CITIZENS FOR FAIR UTILITY REGULATION
7600 Anglin
Fort Worth, Texas 76140

Request to institute a proceeding or for such other action as may be proper under 10 C.F.R., subpart B S2.206

Pursuant to 10 C.F.R., subpart B, S2.206, Citizens for Fair Utility Regulation (hereinafter referred to as CFUR) files this petition with the Executive Director of Operations for the United States Nuclear Regulatory Commission requesting the Director to institute a proceeding to determine if the operating license issued to Texas Utilities Electric Company for the Comanche Peak Steam Electric Station should be revoked for the reasons outlined below.

FIGURE 1

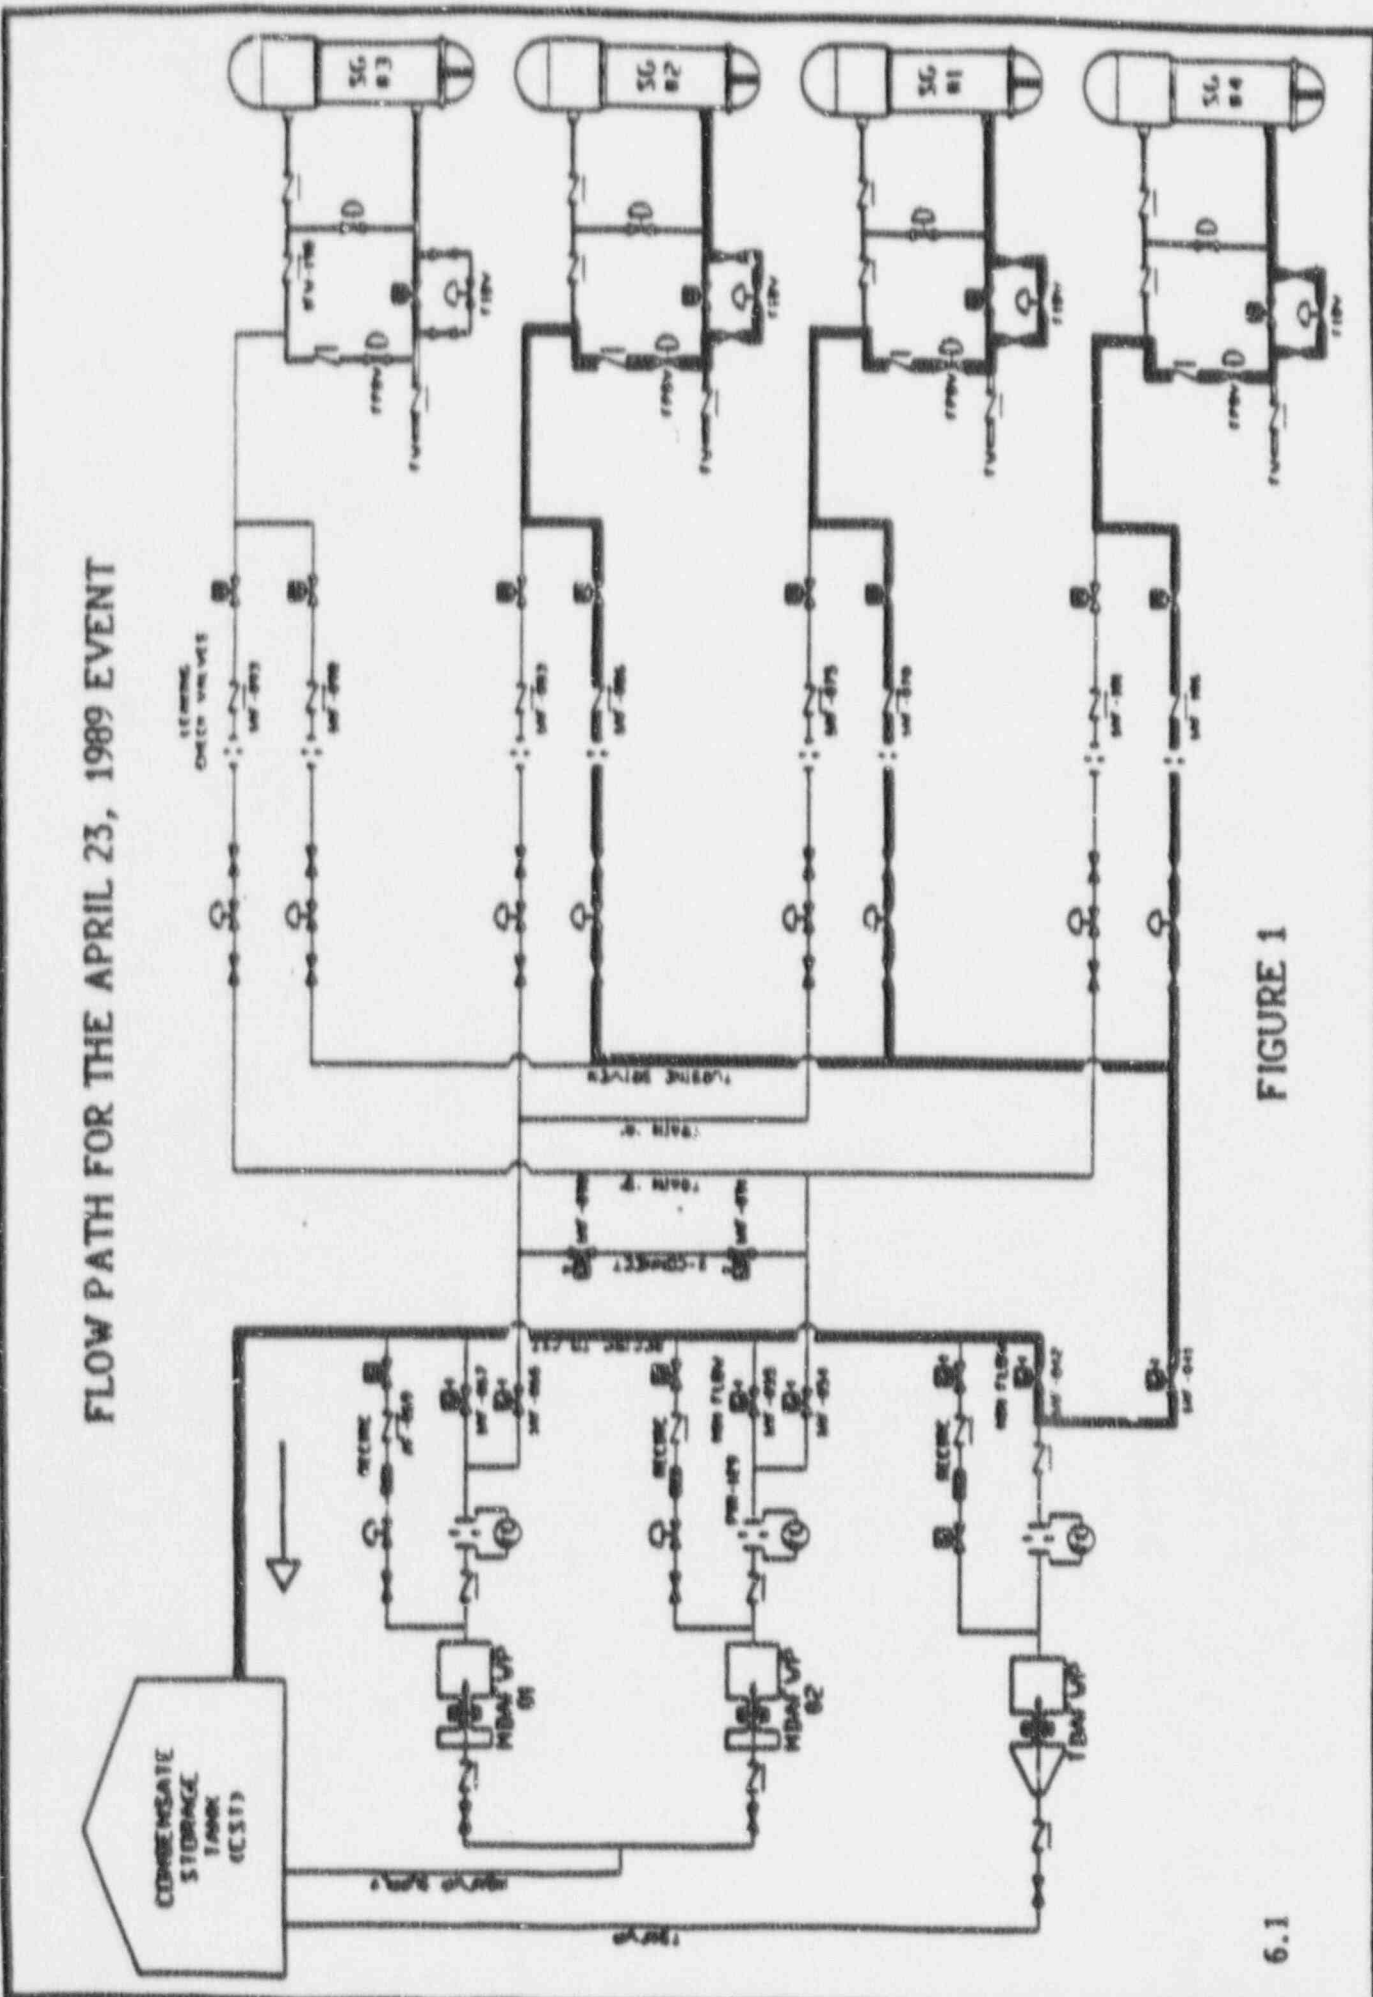
Subsequent testing as described later in this report confirmed that steam generator water leaked back through the closed feedwater isolation bypass valve (d above, See Figure 1).

FIGURE 3

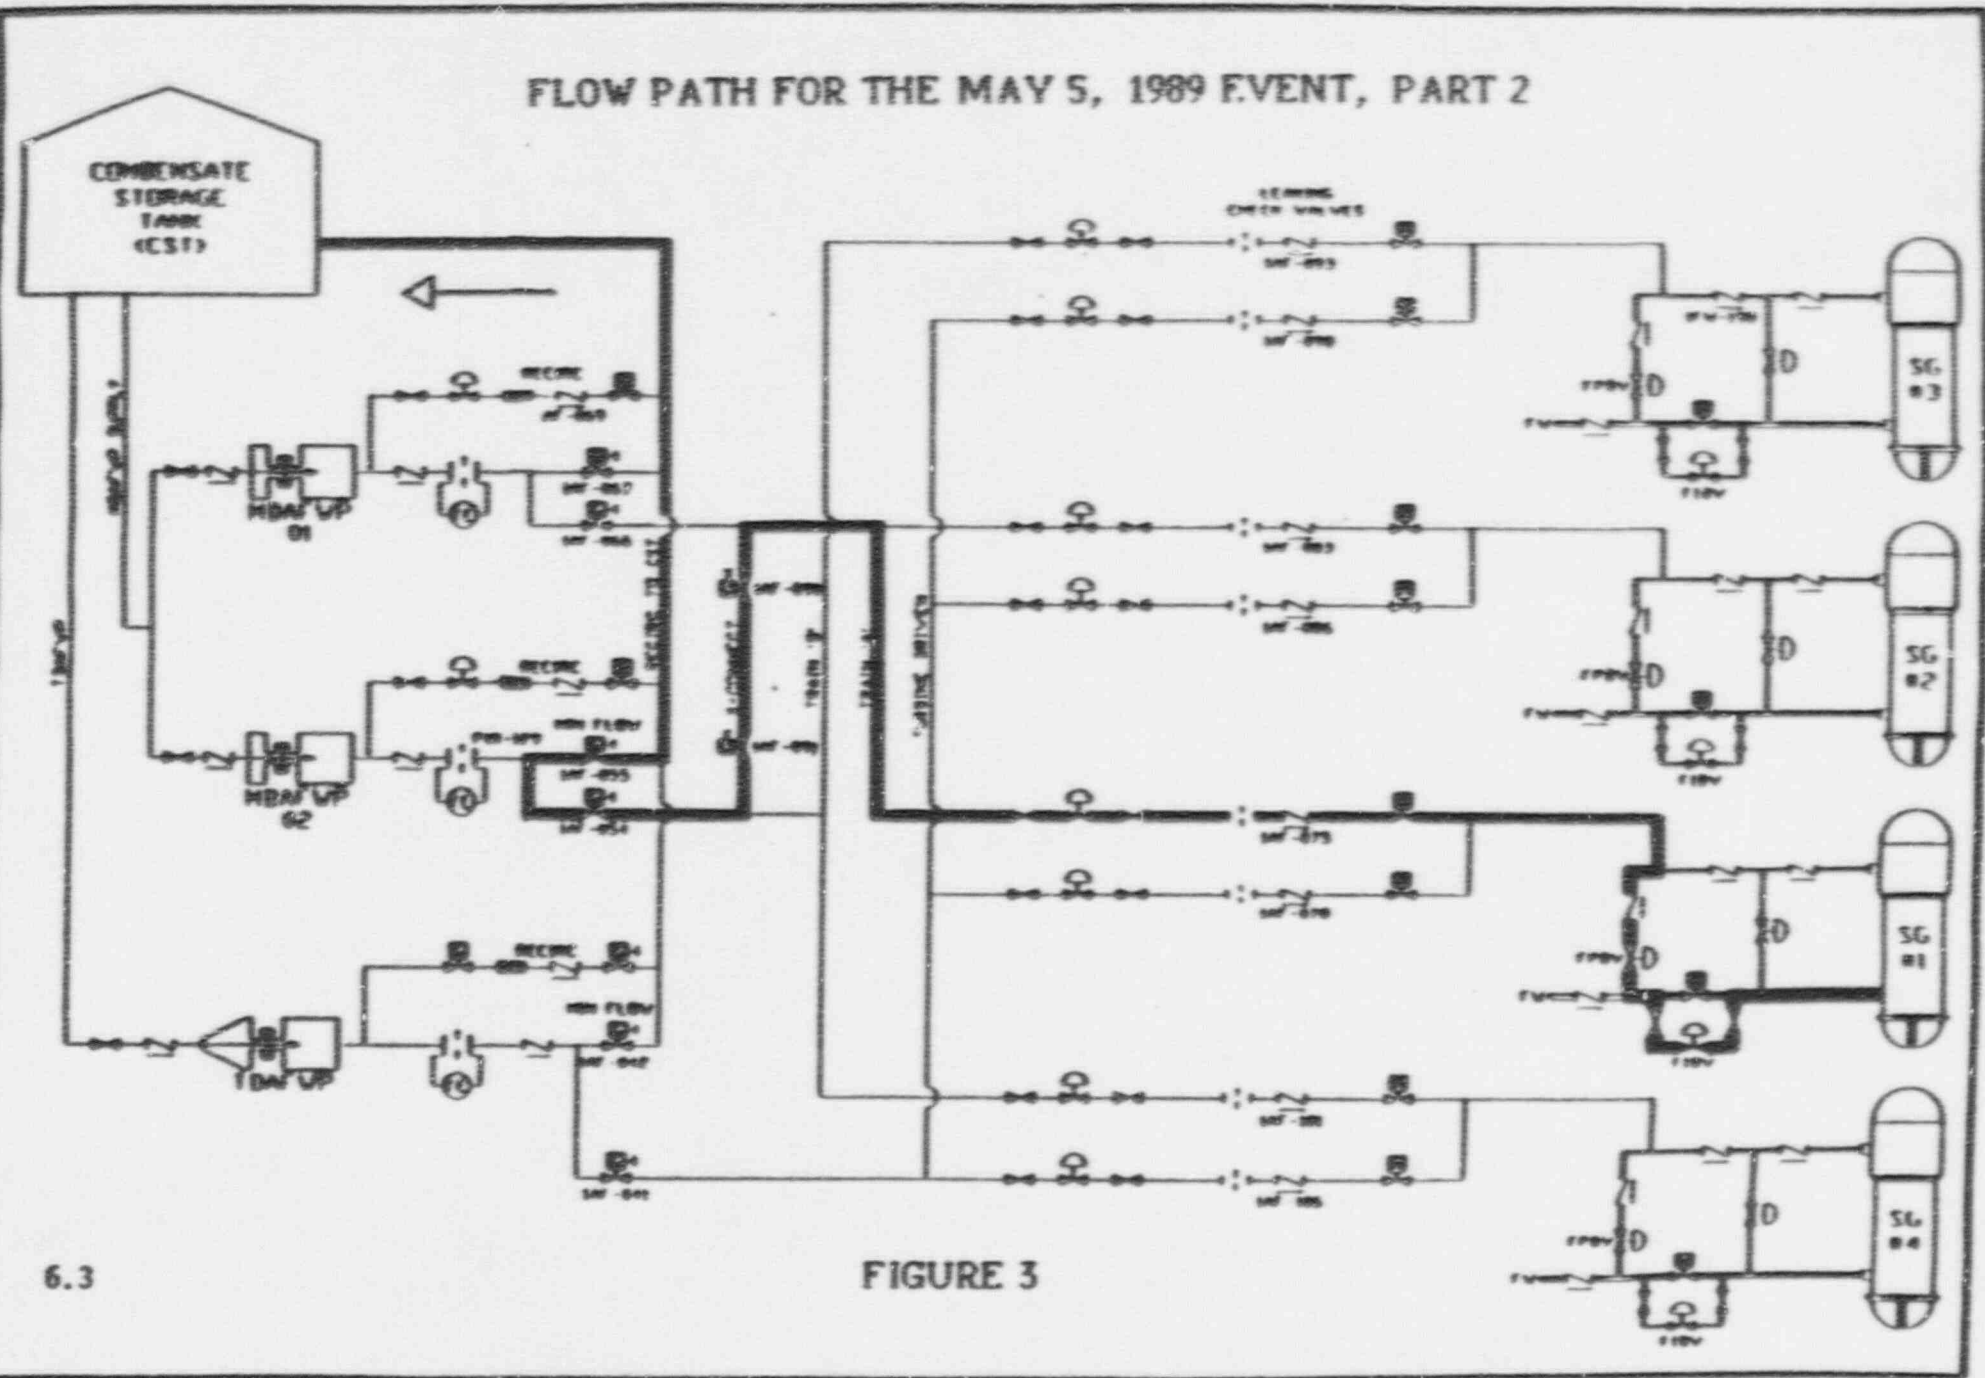
supply line check valve 1AF-106 (in the normal forward flow direction), through MDAFW supply line check valve 1AF-101, and through 1AF-054 and 1AF-055 to the CST (See Figure 3). The backleakage was stopped when valve 1AF-054 was fully closed, after which cross-connect valves 1AF-090 and 1AF-091 were closed.

FIGURE 6

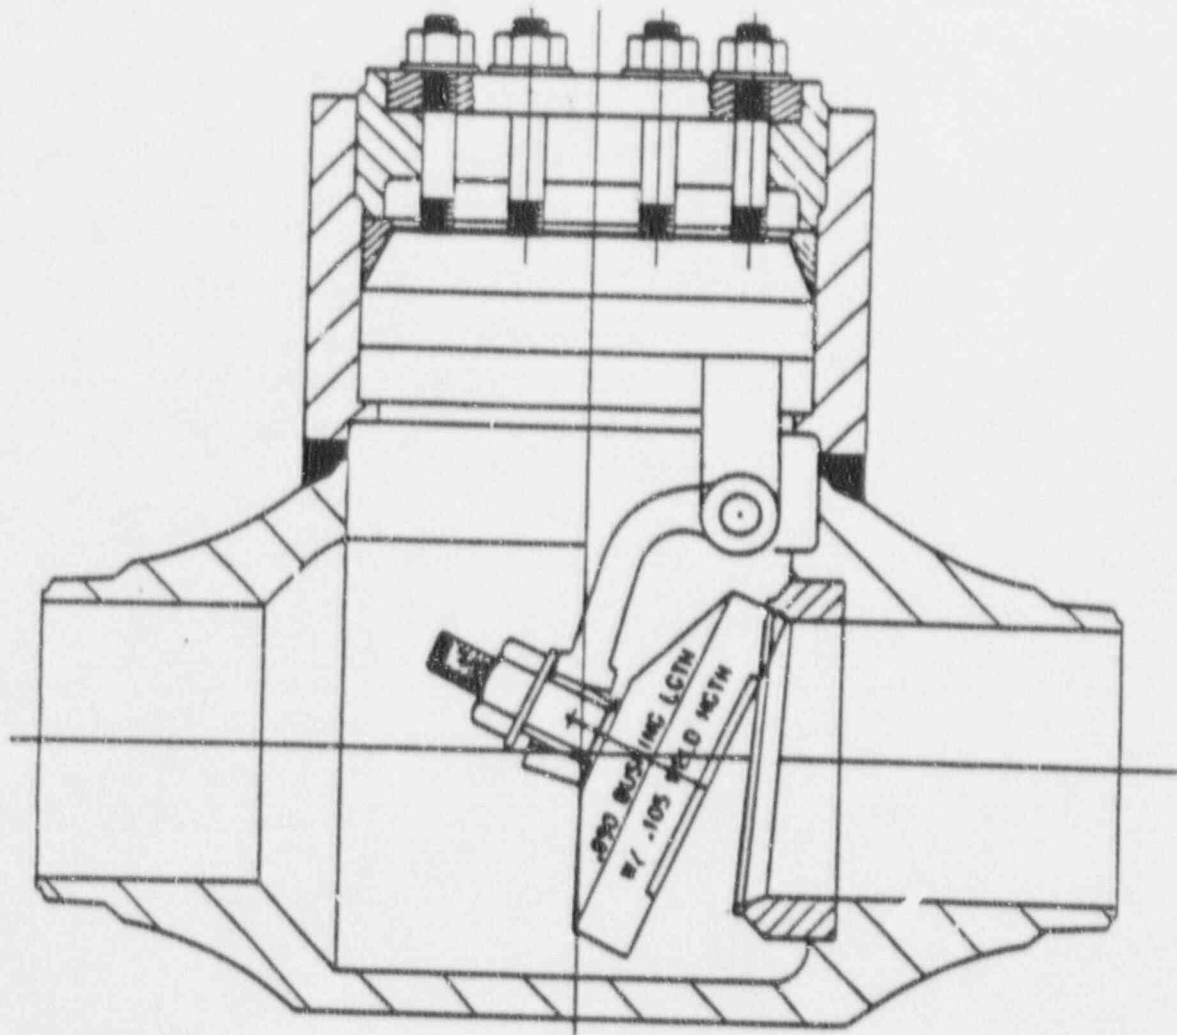
See Figure 6 for summary of valve findings.
